# UNITED STATES PATENT AND TRADEMARK OFFICE

APPLICATION NO.	FILING DATE	FIRST NAMED INVENTOR	ATTORNEY DOCKET NO.	CONFIRMATION NO.
10/701,291	11/04/2003	Bradley S. Berggren	(50035) 60056	5208

<b>Office Action Summary</b>	<b>Application No.</b> 10/701,291	<b>Applicant(s)</b> BERGGREN, BRADLEY S.	
	<b>Examiner</b> Justin M. Larson	<b>Art Unit</b> 3782

**DETAILED ACTION**

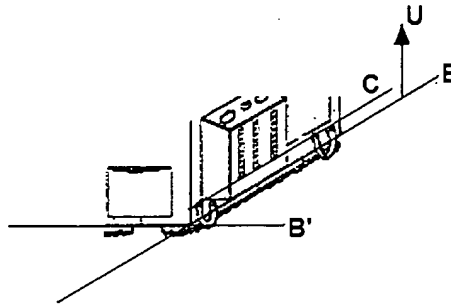
9. Applicant's arguments filed 10/17/06 with respect to Pesce have been fully considered but they are not persuasive. Applicant has asserted that Pesce neither teaches nor suggests the front end portion (top half portion) and rear end portion (top half portion) being in substantially the same plane. Applicant further asserts that Pesce neither teaches nor suggests an elongate base that defines a front end portion dimensioned and configured for attachment to a center console located between two adjacent seats.

Regarding the front and rear ends being in substantially the same plane, referring to the figure on the left below, the front and rear ends (F, R, below) both clearly exist in precisely the same plane (P).

Regarding the front end portion being dimension and configured for attachment to the center console, the front end (F) of Pesce is of such a size and shape that it is capable of being attached to the center console in a vehicle. Claim 1 recites only functional language implying that the front end is capable of being attached to the center console in a vehicle. Fasteners (52) could be used to secure the front end of Pesce to a center console if one so desired. Structurally, there is nothing stopping one from doing so. There is no language in the claim requiring that the front end be positively attached to the center console of a vehicle.

Regarding the existence of a channel in an upper surface of the organizer of Gioso, Examiner presents the following figure and explanation.

The figure above shows a portion of the front end of the Gioso organizer. Lines (B) and (B') have been drawn level with the bottom surface of the organizer. Examiner is of the position that any surface that is above the bottom surface in a direction (U) can be considered an upper surface to the degree that such a surface is above the bottom of the organizer. The channels of Gioso are shown to be attached to an upper surface at a level (C) which is clearly above the bottom surface of the organizer. The longitudinal axis of the surface on which the channels are attached can be considered to be that axis which is in the direction of (U) above. The channels are attached across the surface along line (C) making them perpendicular to the longitudinal axis (U).
